**CITY OF TACOMA**  
**Public Work Engineering Division**

**ADDENDUM NO.1**

**REVISIONS TO:**  
**Request for Bids Specification No. PW20-0231F**  
**East Portland Avenue Improvements**

TS31

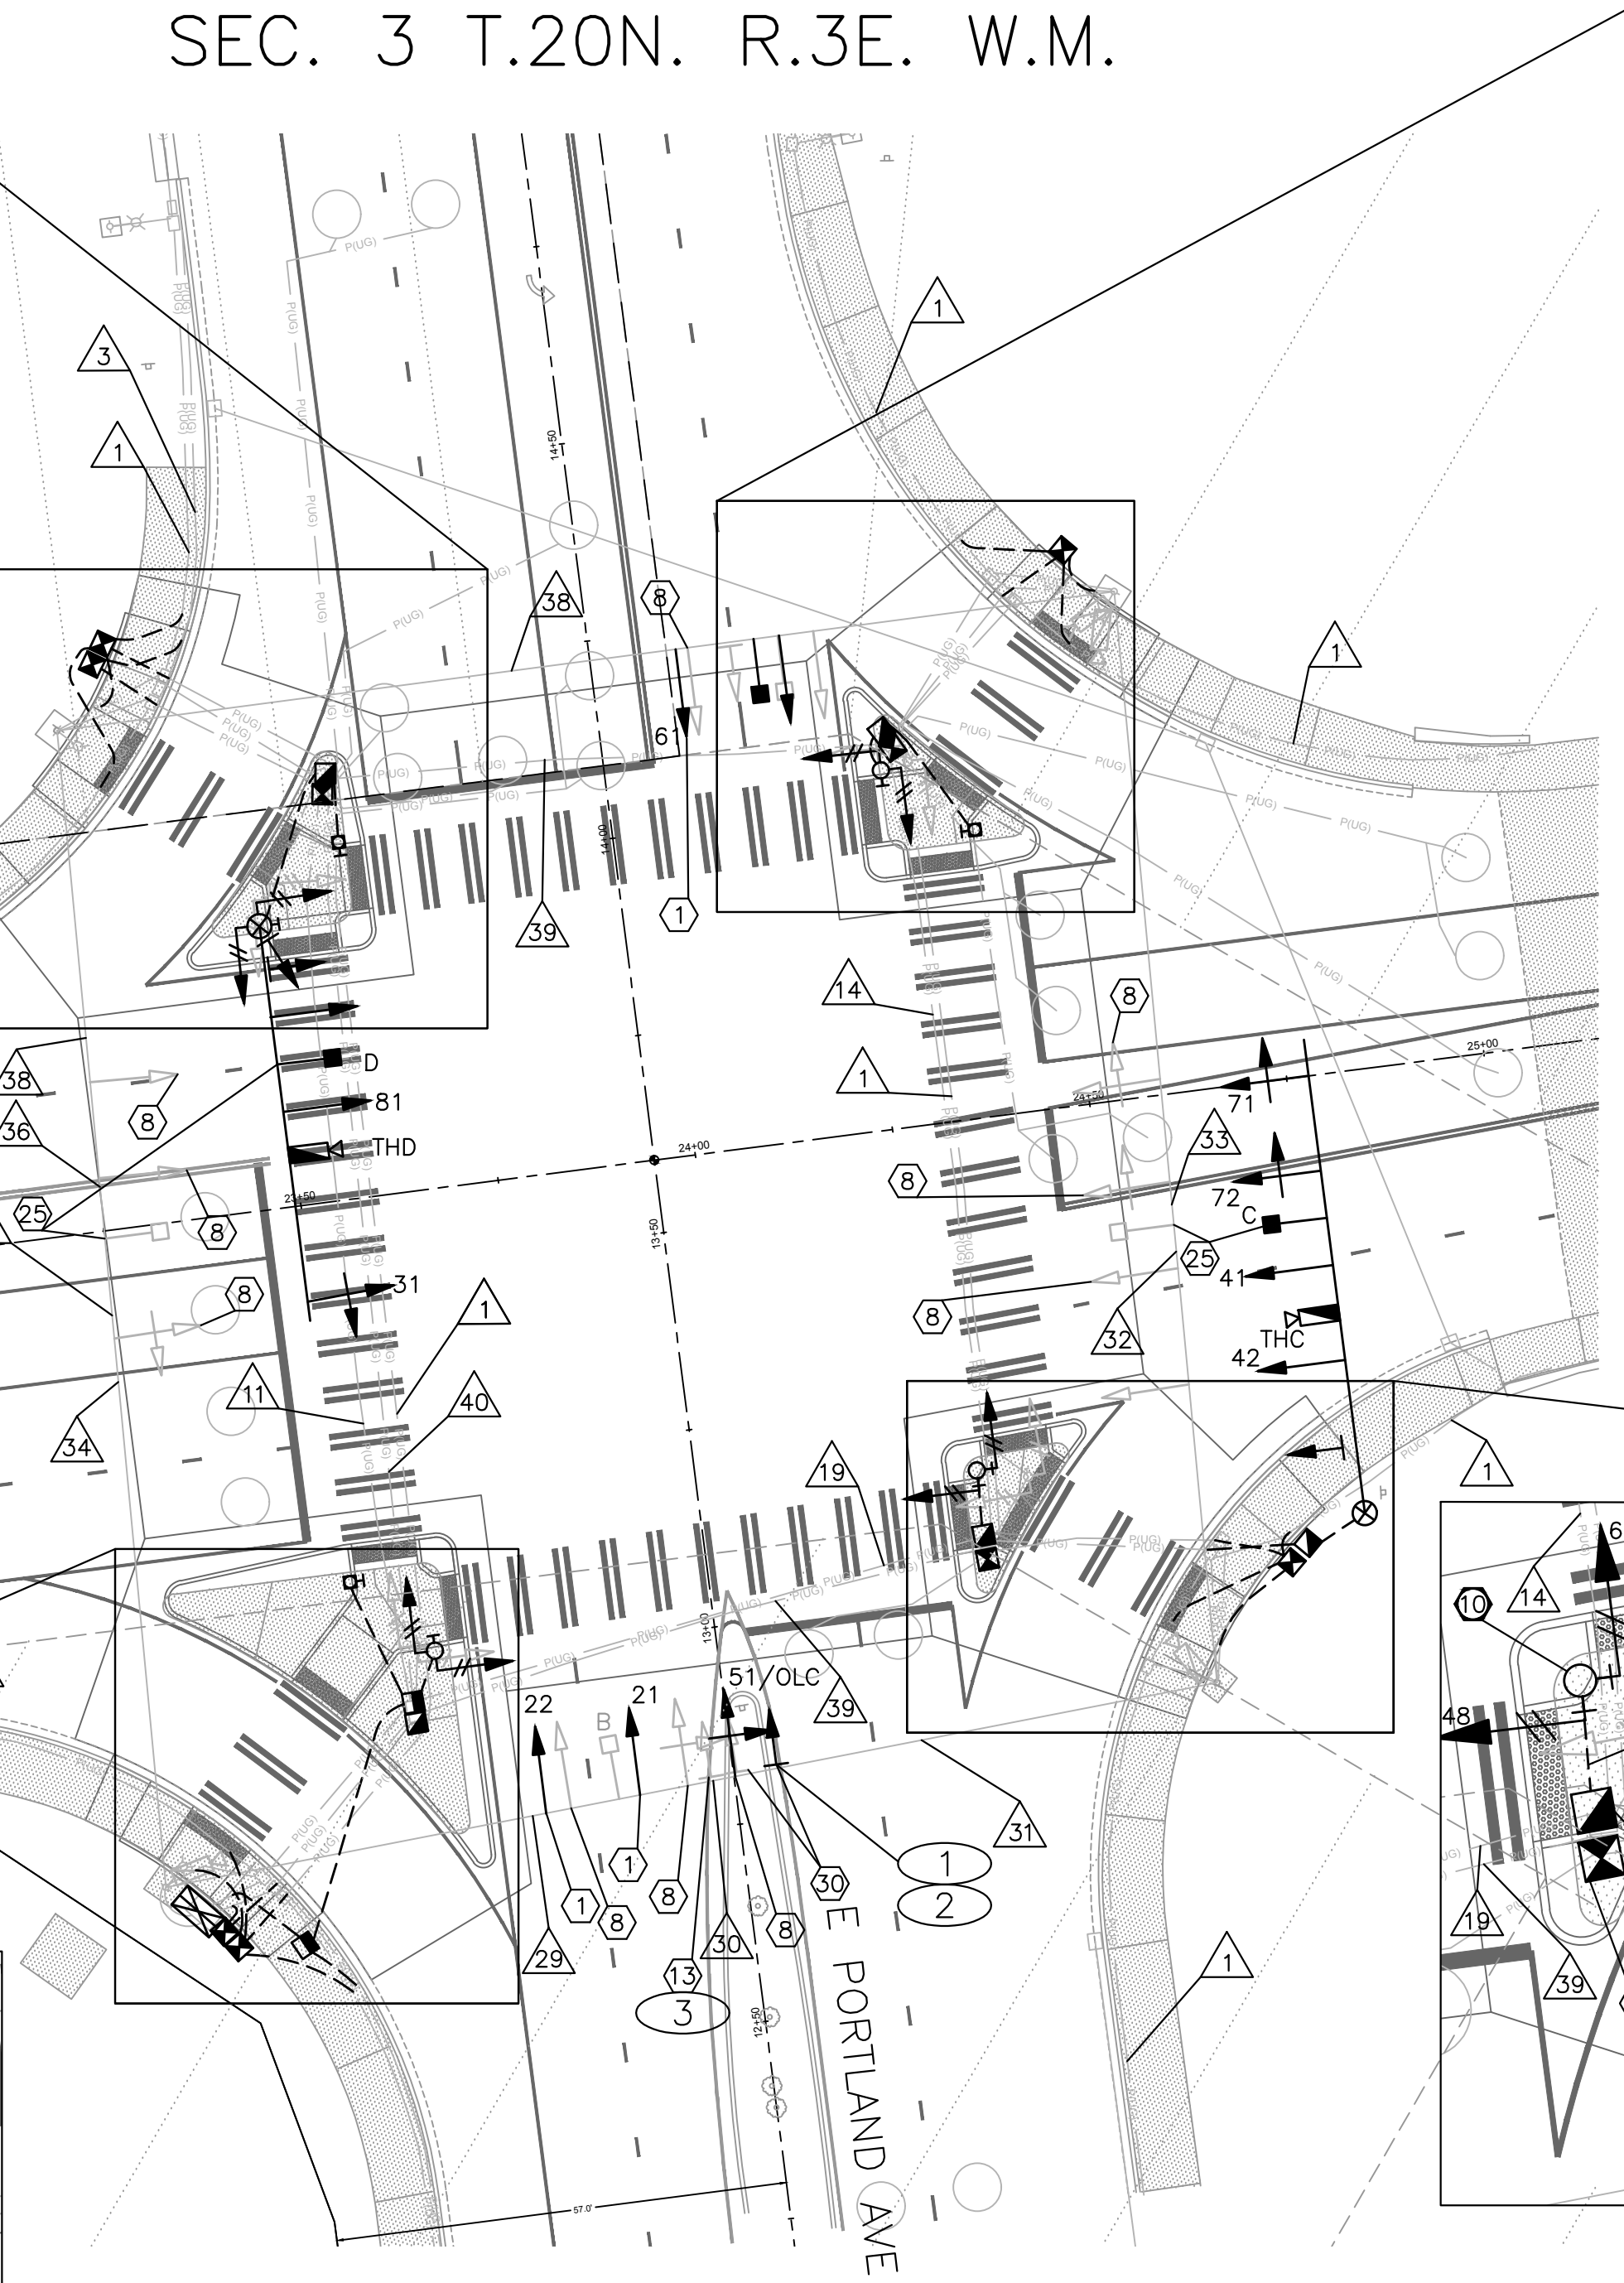
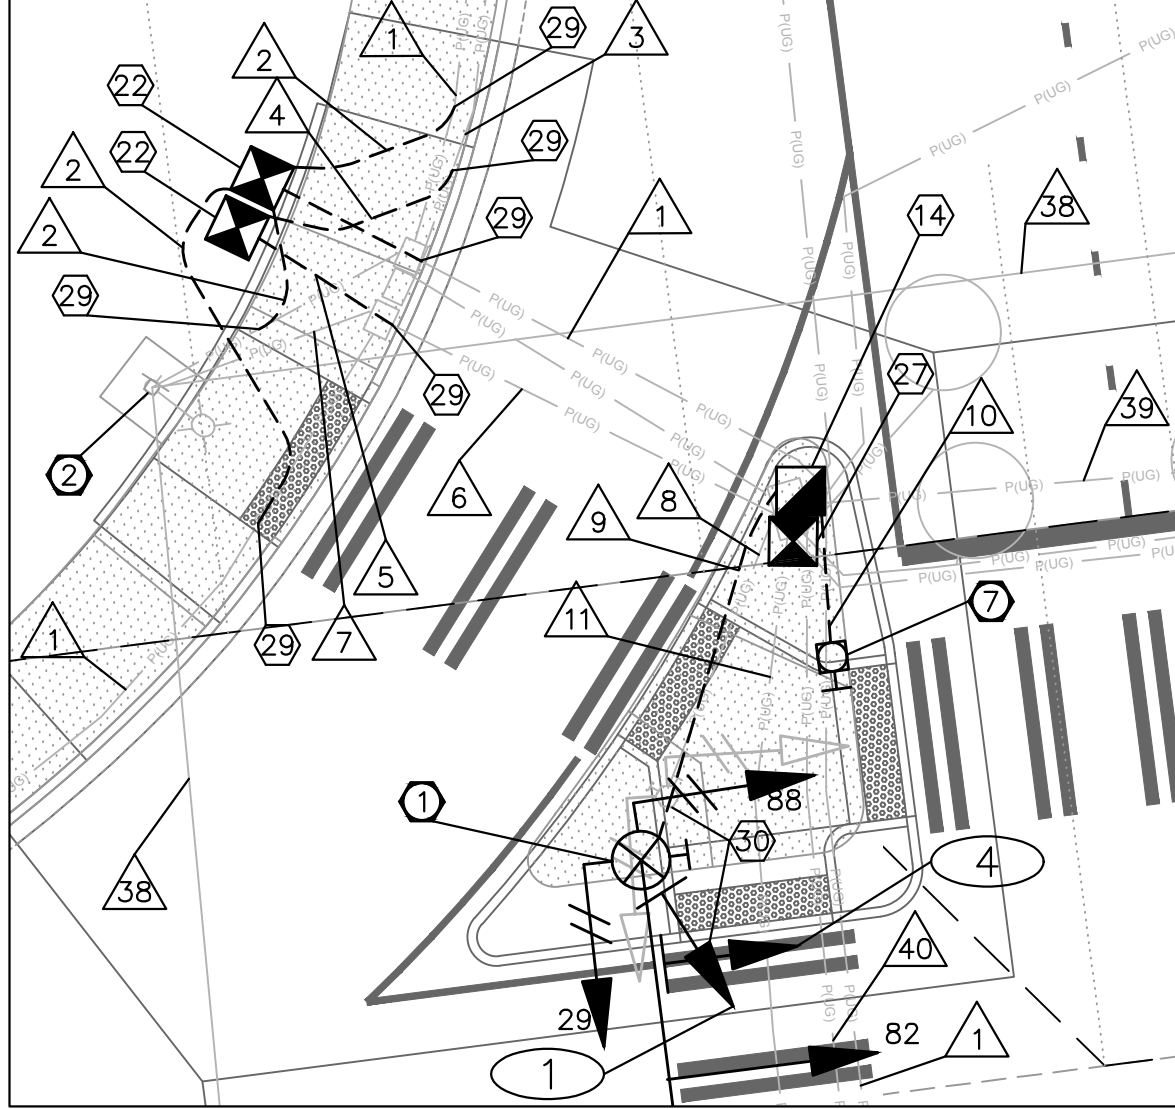
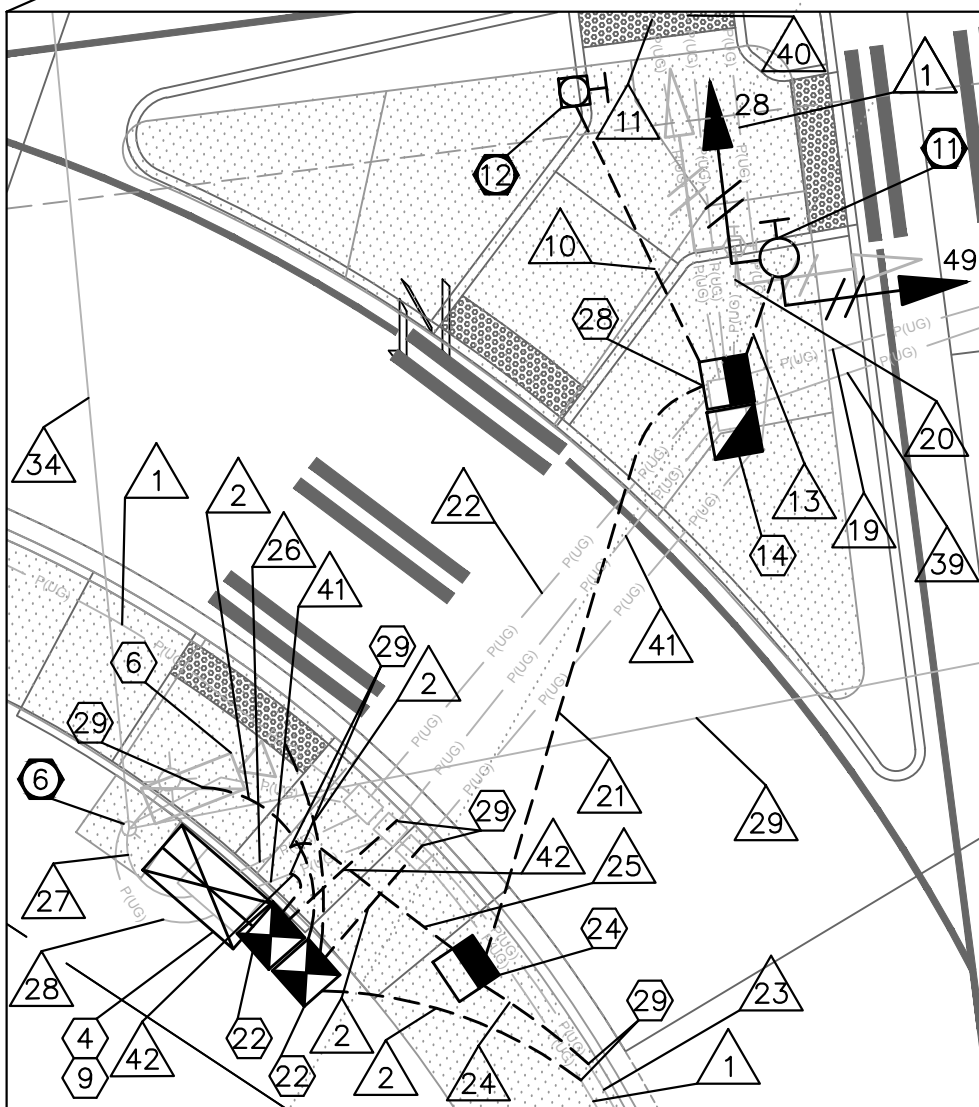
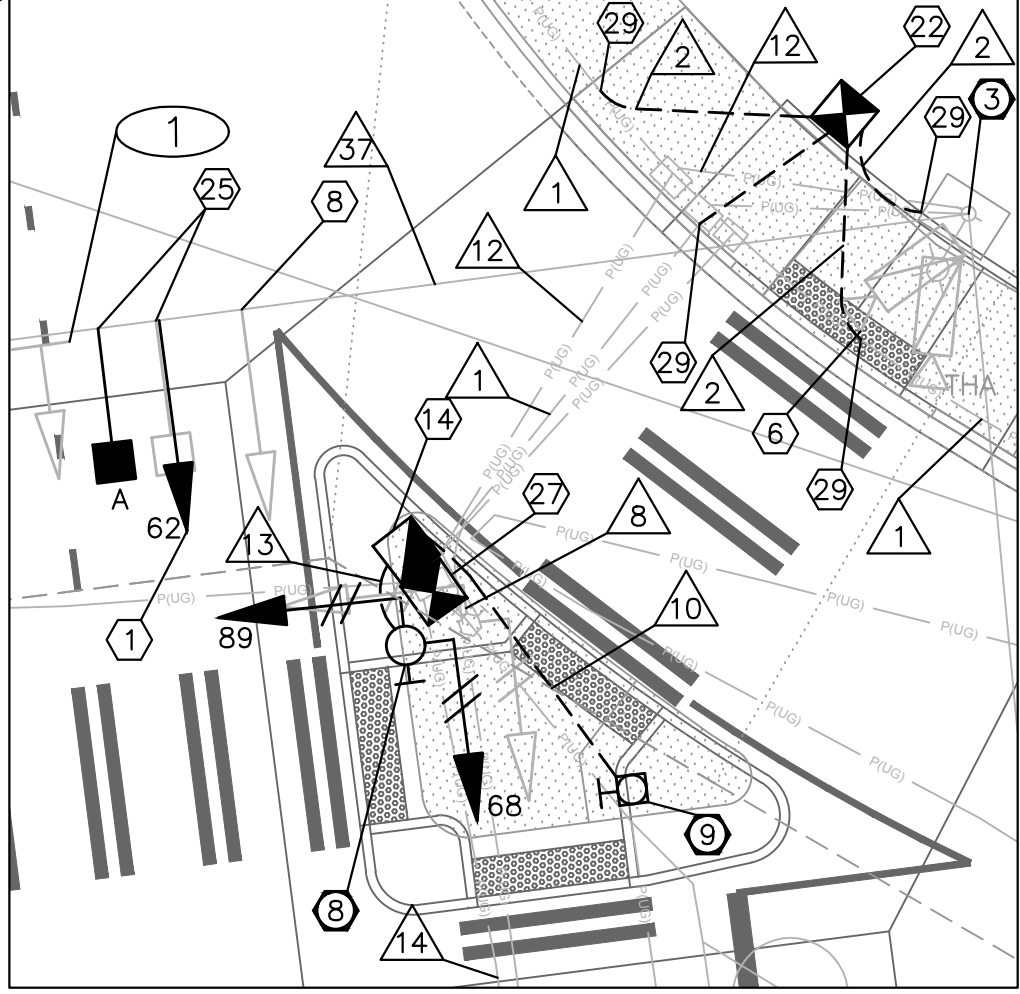
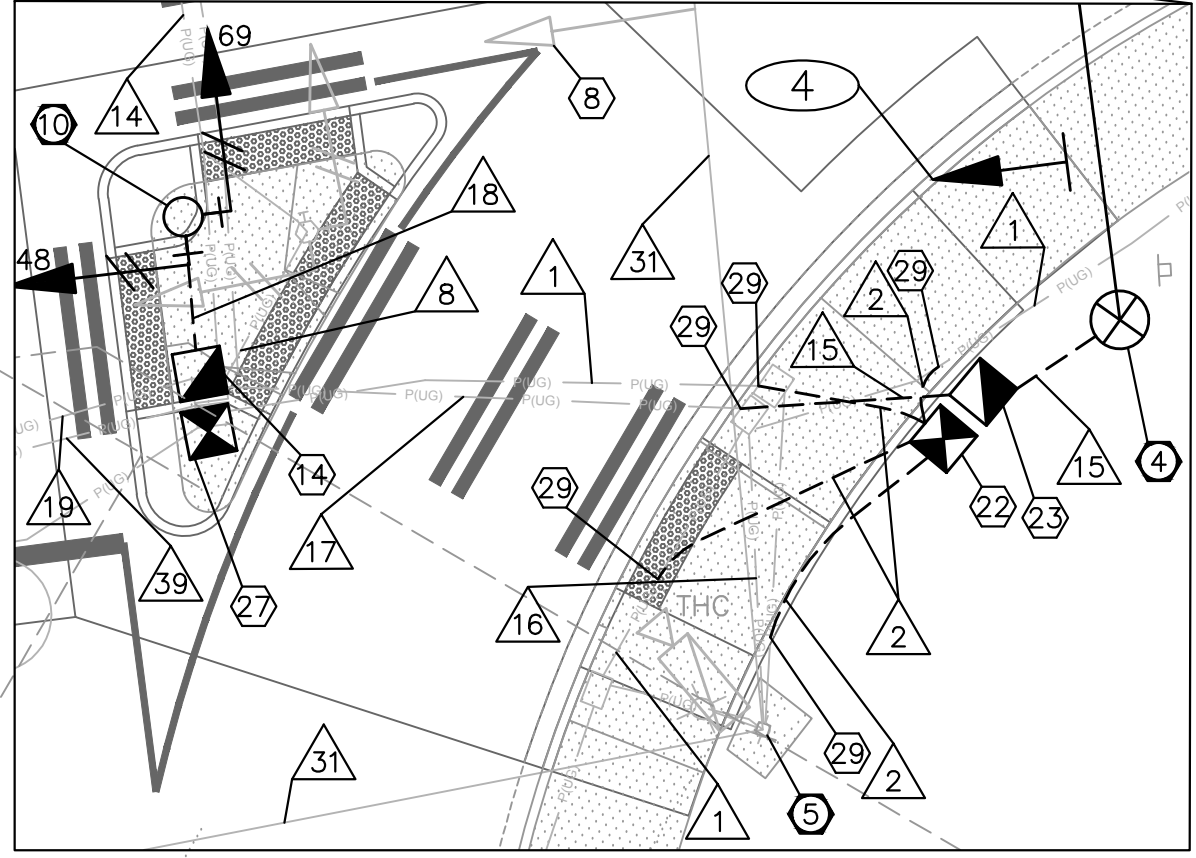
Replace plan sheet TS31 in its entirety and replace with the following attached labeled Addendum #1.

TS07

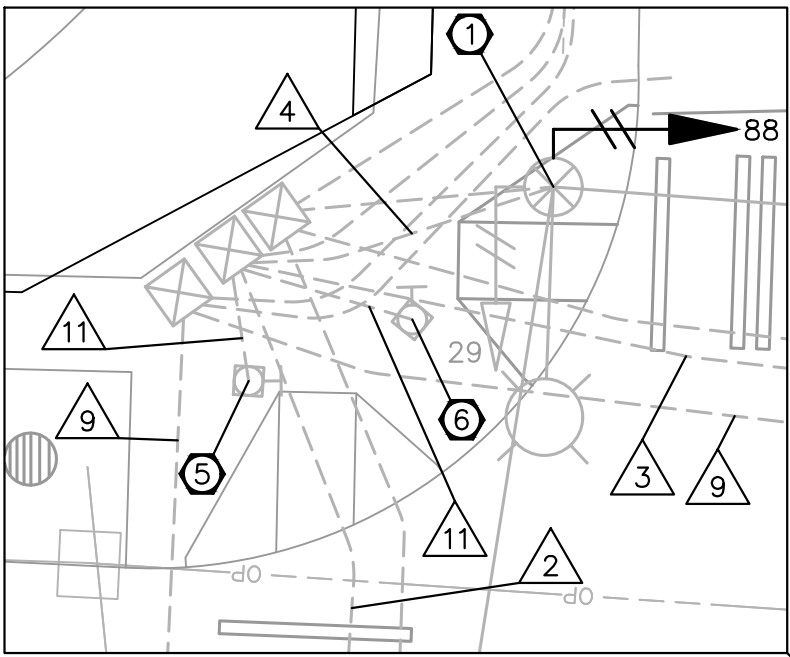
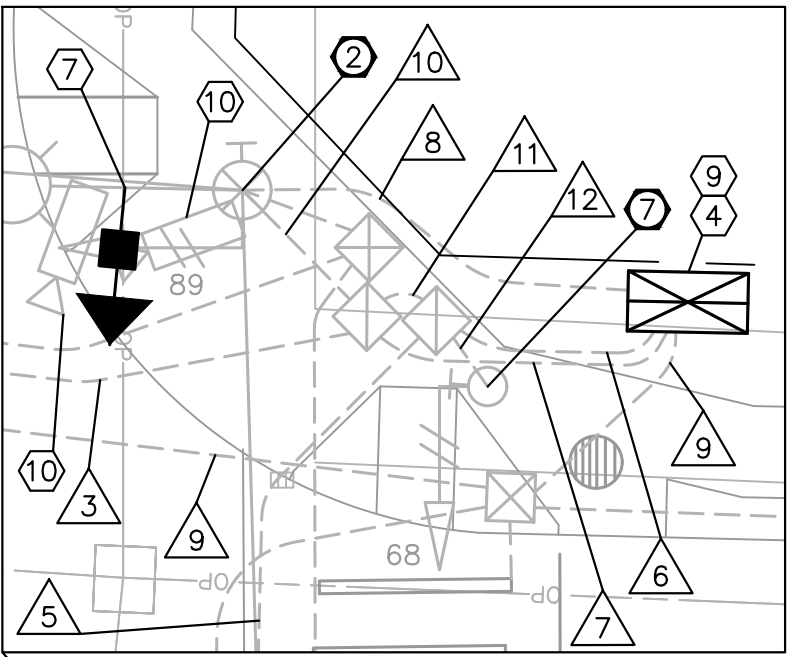
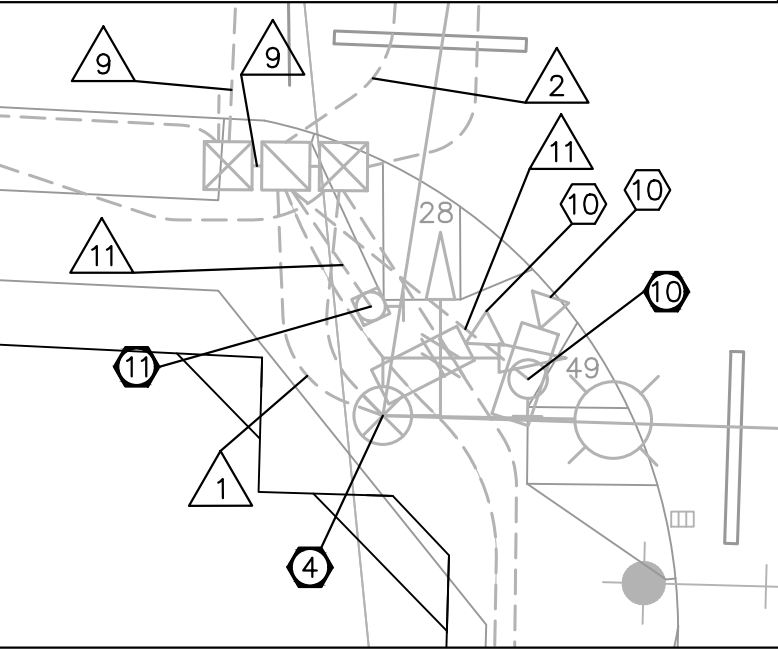
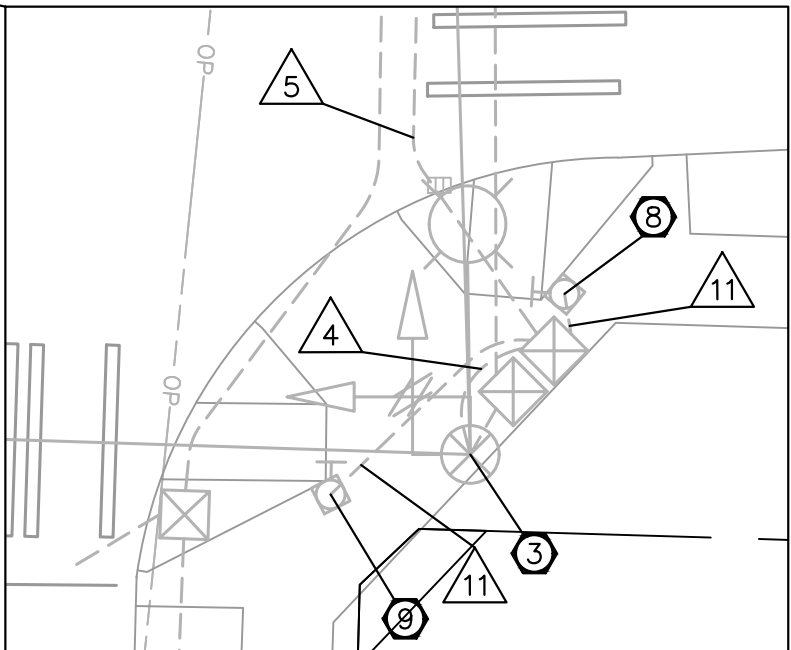
Information regarding the NW corner of 56<sup>th</sup> and Portland Ave, Plan sheet TS07.

Work at the NW corner of 56<sup>th</sup> and Portland shall not commence until case number 20- 2-07230-9 has been closed, closure of this case is anticipated to be October 2021. The work on the SW, NE, & SE corners of 56<sup>th</sup> & Portland Ave. may be constructed prior to

the closure of Case No. 20-2-07230-9 provided ADA accessibility is maintained at all times throughout construction.

Please see addendum  
#1 for information regarding  
the NW Corner
